SUNDRY NOTICES AND REPORTS ON WELLS (DO NOT USE THIS FORM FOR PROPOSALS TO DRILL OR TO DEEPEN OR PLUG BACK TO A DIFFERENT RESERVOIR. USE "APPLICATION FOR PERMIT" (FORM C-101) FOR SUCH PROPOSALS.)		WELL API NO. 30-025-06226
1. Type of Well: Oil Well <input type="checkbox"/> Gas Well <input type="checkbox"/> Other. WIW		5. Indicate Type of Lease STATE <input checked="" type="checkbox"/> FEE <input type="checkbox"/>
2. Name of Operator Mar Oil & Gas Corporation		6. State Oil & Gas Lease No.
3. Address of Operator PO Box 5155 Santa Fe, NM 87502		7. Lease Name or Unit Agreement Name Eumont Hardy Unit
4. Well Location Unit Letter M : 660 feet from the South line and 660 feet from the West line Section 36 Township 20S Range 37E NMPM Lea County		8. Well Number. 20
11. Elevation (Show whether DR, RKB, RT, GR, etc.)		9. OGRID Number 151228
		10. Pool name or Wildcat Eumont; Yates, 7 Rivers, Queen

SUNDRY NOTICES AND REPORTS ON WELLS
(DO NOT USE THIS FORM FOR PROPOSALS TO DRILL OR TO DEEPEN OR PLUG BACK TO A DIFFERENT RESERVOIR. USE "APPLICATION FOR PERMIT" (FORM C-101) FOR SUCH PROPOSALS.)
1. Type of Well: Oil Well [] Gas Well [] Other. WIW
2. Name of Operator Mar Oil & Gas Corporation
3. Ad

Mar Oil & Gas Corp
Eumont Hardy Unit # 20
API 30-025-06226
LEA COUNTY, NM

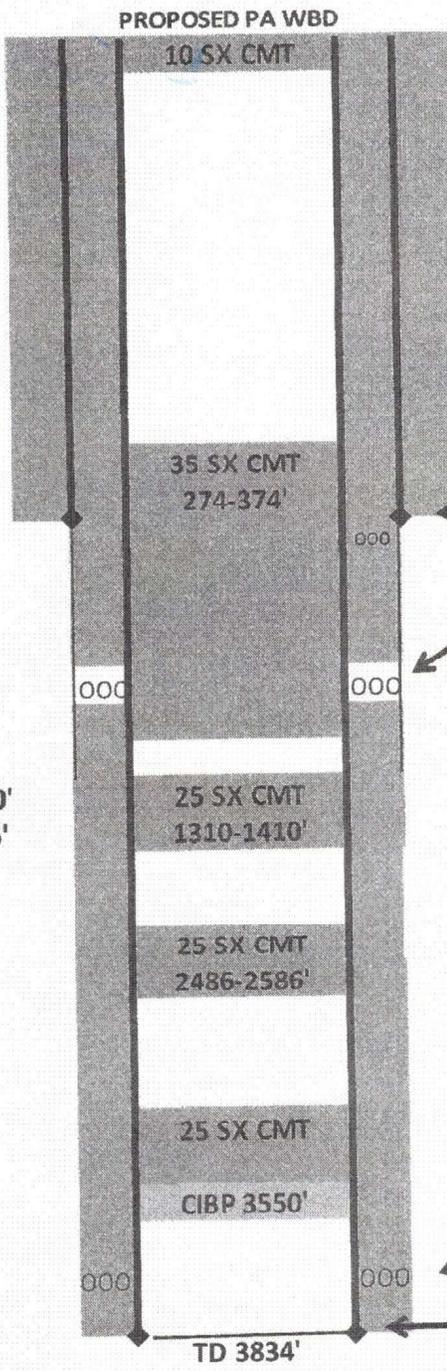
LPC area below ground marker take pics before back filling

Note changes to procedure
